UNITED STATES PATENT AND TRADEMARK OFFICE

APPLICATION NO.	FILING DATE	FIRST NAMED INVENTOR	ATTORNEY DOCKET NO.	CONFIRMATION NO.
10/729,384	12/08/2003	Nathaniel Ian Joos	9351-324	8153
1059	7590	01/22/2008	EXAMINER	
BERESKIN AND PARR 40 KING STREET WEST BOX 401 TORONTO, ON M5H 3Y2 CANADA			CANTELMO, GREGG	
			ART UNIT	PAPER NUMBER
			1795	
			MAIL DATE	DELIVERY MODE
			01/22/2008	PAPER

Office Action Summary	Application No. 10/729,384	Applicant(s) IAN JOOS ET AL.	
	Examiner Gregg Cantelmo	Art Unit 1795

DETAILED ACTION

FIG. 5

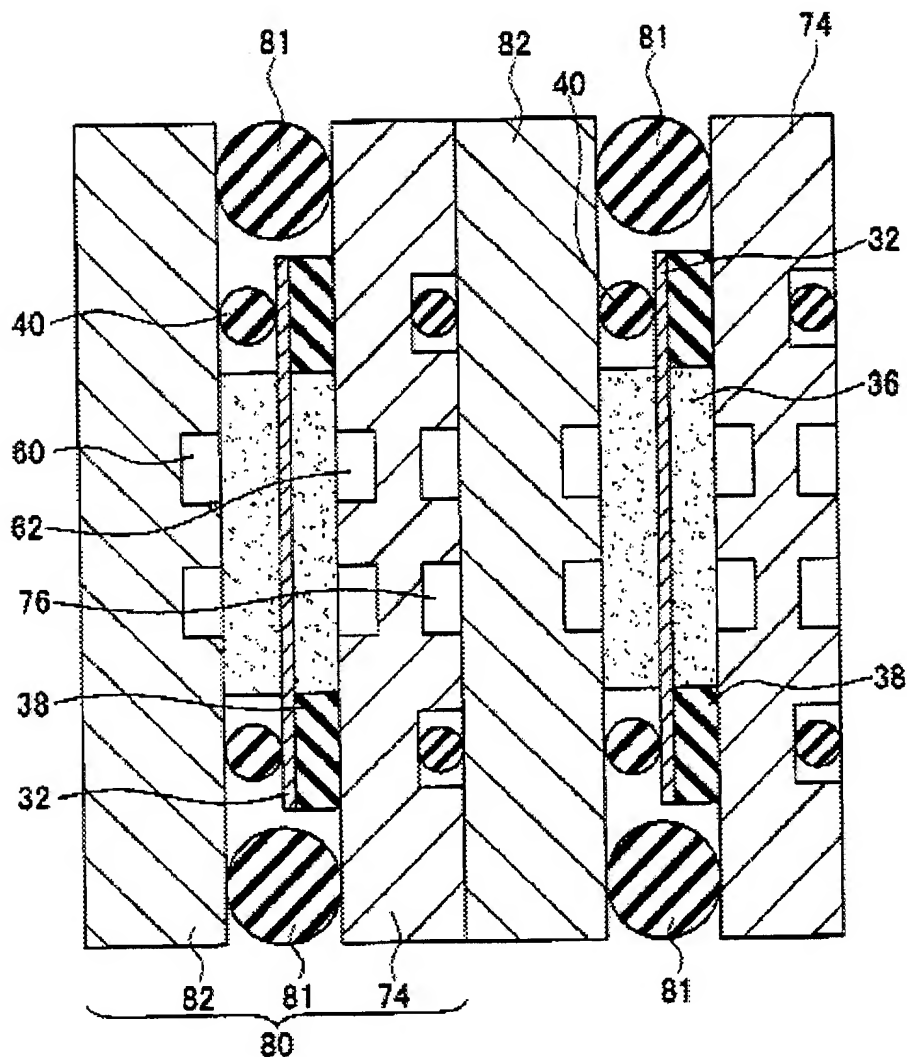
Sugita discloses: a membrane electrode assembly 32 disposed between a first reactant flow field plate 74 and a second reactant flow field plate 82 (Fig. 5); a first gas diffusion layer 36 disposed between the membrane electrode assembly 32 and the first reactant flow field plate 74 for diffusing reactant from the first reactant flow field to the membrane electrode assembly, the first gas diffusion layer 36 including a body portion and an edge portion (Fig. 5).

FIG. 8

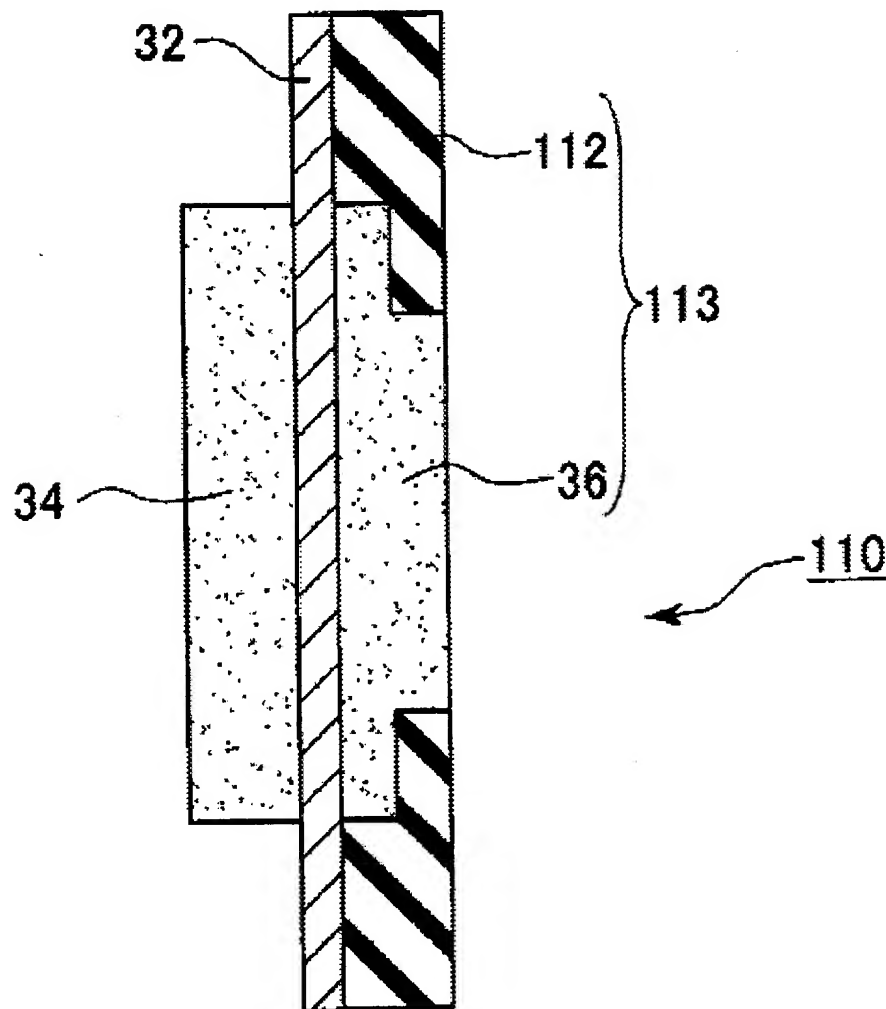
In one embodiment, Fig. 8, Sugita discloses the edge portion having reduced thickness providing a step between the body portion and the edge portion, the step provided on a first side of the first gas diffusion layer facing away from the membrane electrode assembly 32 (thus toward the flow field); and a first seal 12 disposed between

the first reactant flow field plate and the membrane electrode assembly for impeding leakage of process fluids. The configuration below is such that the gas diffusion layer 36 provides a substantially flat surface immediately adjacent to the membrane electrode assembly 32 for supporting the assembly (as applied to claim 31).

While only shown for one side, one of ordinary skill in the art would reasonably employ the same seal structure of Fig. 8 to both sides of the membrane electrode assembly and thus to the second gas diffusion layer as recited in claim 32. The

The gas diffusion layers 36 are shown as a single unitary construction (Fig. 8 as applied to claim 34).

FIG. 10

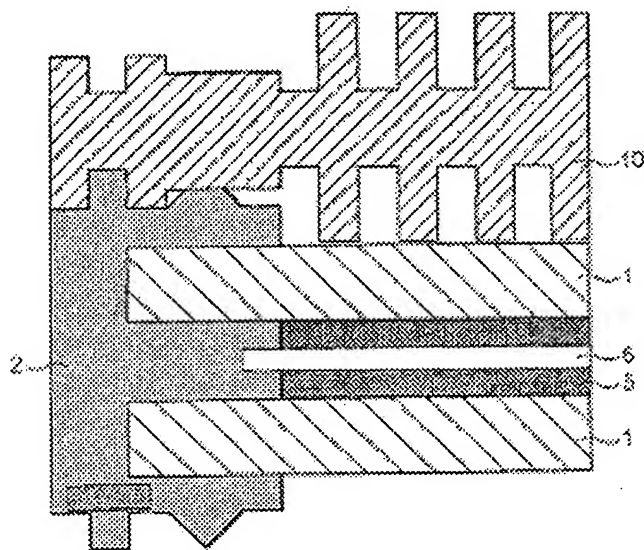
WO '669 discloses: a membrane electrode assembly 5/6/5 disposed between a first reactant flow field plate 10 and a second reactant flow field plate (not shown but inherently disposed adjacent to the lower electrode diffusion layer 1 (Fig. 10); a first gas diffusion layer 1 disposed between the membrane electrode assembly 5/6/5 and the first reactant flow field plate 10 for diffusing reactant from the first reactant flow field to the

membrane electrode assembly, the first gas diffusion layer 1 including a body portion and an edge portion (Fig. 10).

FIG. 3

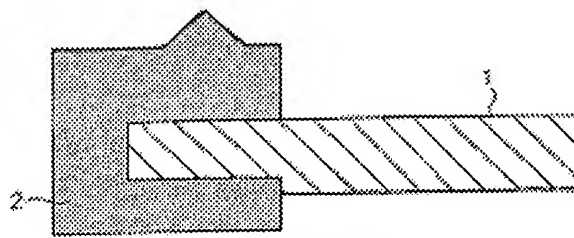
In one embodiment, Fig. 3 of WO '669 discloses the edge portion having reduced thickness providing a step between the body portion and the edge portion, the step provided on a first side of the first gas diffusion layer facing the membrane electrode assembly; and a first seal disposed between the first reactant flow field plate and the membrane electrode assembly for impeding leakage of process fluids.

The seal material 2 is a compressible material and upon compression of the stack it is reasonable to expect that the bottom portion of the seal 2 shown in Fig. 3 above will compress between the diffusion layer and membrane electrode assembly such that the seal abutting the edge portion of the first gas diffusion layer and having a height that corresponds to a height of the step of the first gas diffusion layer such that a second side of the first gas diffusion layer (lower surface in Fig. 3 as disposed in the arrangement shown in Fig. 1) facing the membrane electrode assembly provides a substantially flat first surface for supporting the membrane electrode assembly (as applied to claim 31).

While only shown for one side, one of ordinary skill in the art would reasonably employ the same seal structure of Fig. 3 to both sides of the membrane electrode assembly and thus to the second gas diffusion layer as recited in claim 32. The structure and relationship of the second gas diffusion layer, second seal and membrane electrode assembly recited in claim 32 is identical to the structure and relationship recited to the first gas diffusion layer, first seal and membrane electrode assembly. Therefore the discussion above to the first diffusion layer, first seal and membrane
